Additional Information for Appeal (Case #ZA-2022-2735-CU-1A)

Frank Arlotti, Appellant. Owner of 23007 Del Valle St, Woodland Hills.

This appeal focusses on:

Via Del Valle
Townhouses
Entrance Gate.
(11-25-2022)

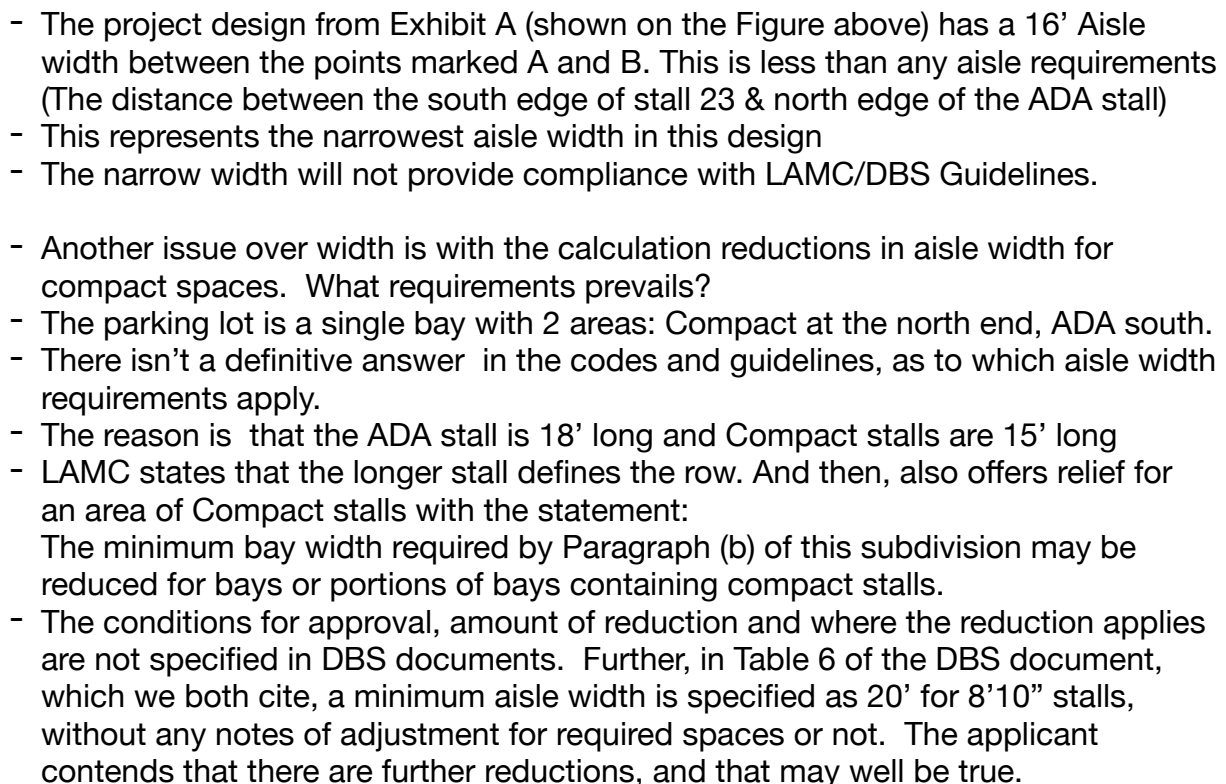
- Conditions for Compatibility with the residences design and appearance are not included: ie., wrought iron fencing where visible at the street, decorative block or stucco finish and color similar to the residences. [see photos page 5]

- Compatibility with the residences design and appearance: ie., wrought iron fencing where visible from the street, decorative block or stucco finish and color similar to the residences.
